## MEMORANDUM

**RE:** Zena Homes Subdivision & Site Plan- P-937  
Ruby Woods  
SBL: 39.1-1-21.100

**DATE:** October 12, 2025

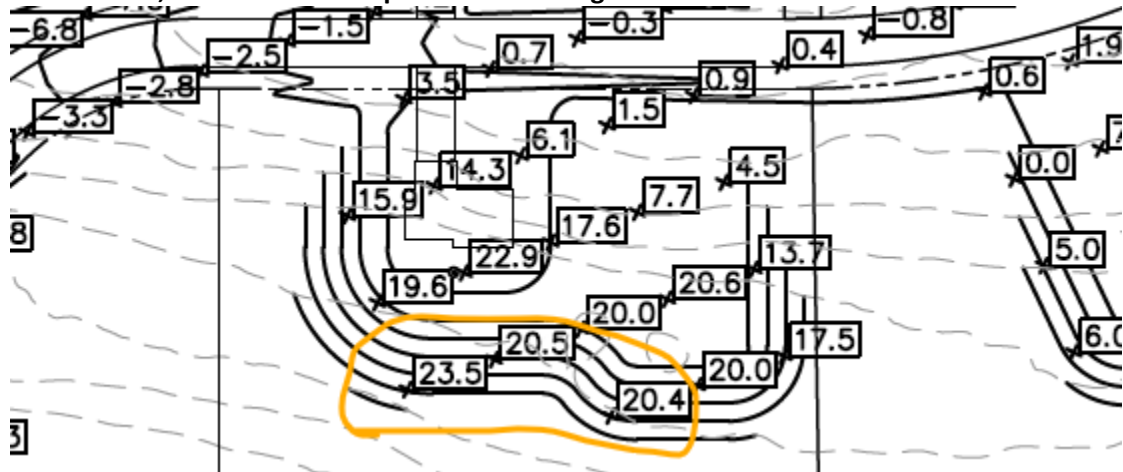
- 5. The applicant is clearing and grading far larger home sites than is necessary resulting in far more land disturbance than is necessary to create marketable and saleable homesites. The applicant should take a more terrain adaptive/less impactful approach rather than attempting to provide a single expansive flattened area on each lot.

**10/12- As stated above, we recommend that the applicant meet with the Town Engineer to determine if there is a less impactful alternative possible to the proposed layout.**

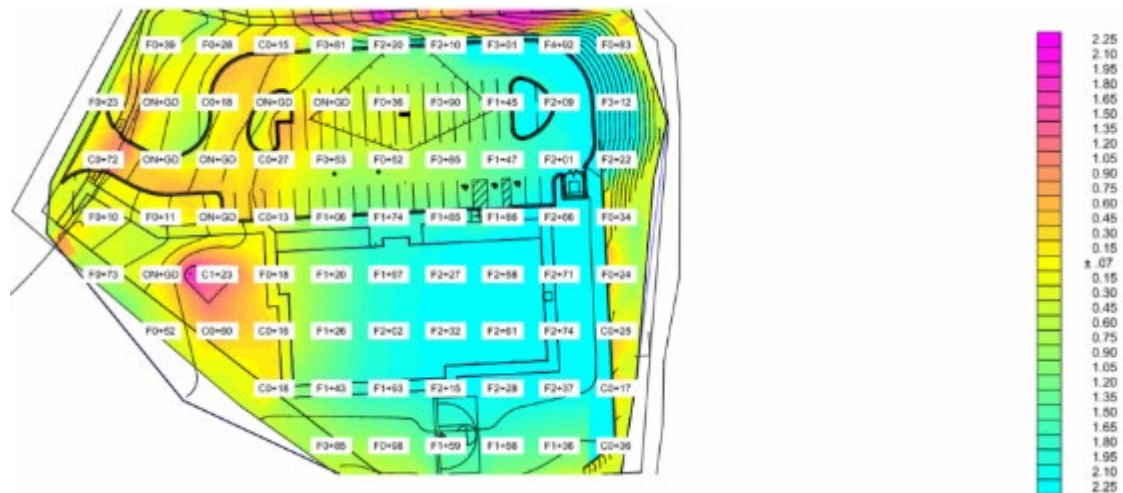
- 6. New Comment 8/5. The combined clearing and grading map has improved our understanding of the lot significantly, however, it is still difficult to understand how this site relates to the topography. We recommend the Planning Board require additional maps and figures to be provided for just the Ulster section of the site:

- b. The grading plan with color-referenced to the depths of cuts and fills.

**10/12- The applicant has provided a matrix of spot cut and fills throughout the areas of disturbance. We have several questions on the accuracy of these. For example at the toe of proposed slopes, where there should only be a foot or two of fill, 23.5 feet is indicated. See below. Also, a color-coded map similar to the figure below would be easier to understand.**

c. Several 1:1 cross sections through the lines indicated below.
